# NEW PRODUCT | HEAVY DUTY BRACKET ADAPTOR

PRODUCT DETAILS	
DESCRIPTION.	Medium HD Bracket Adaptor + Screw
CODE.	RB09-0701-050012 (Black)   RB09-0701-069012 (White)
PACK SIZE.	25 Sets
PRICE.	Refer to catalog
IMAGE.	
USE WITH.	Single & Dual Brackets with 12mm tongue, RB09 Chain Winders, 3Nm & 6Nm motors
AVAILABLE.	In stock now

## FUNCTIONAL BENEFITS

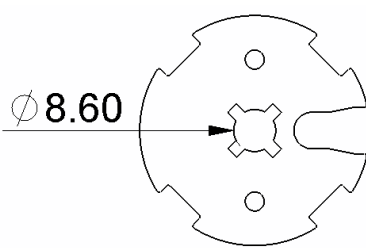
- 3Nm and 6Nm motors are now compatible with all RB Double Bracket solutions
  - Requires the motors to use the latest disc adaptors (refer associated PCL's)
- Robust solution for chain winders in commercial applications
  - Designed to protect the 12mm bracket tongue against excessive chain operation force
- Can be retrofit to existing installations
  - Remove shade from bracket, install HD Bracket adaptor, re-install shade
  - Requires additional 1.5mm idler clearance

## PRODUCTION / INSTALLATION

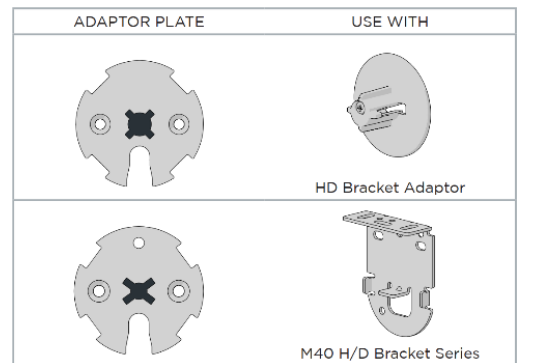
- Must allow for additional 1.5mm deduction during fabrication
- Screw requires #1 Phillips head
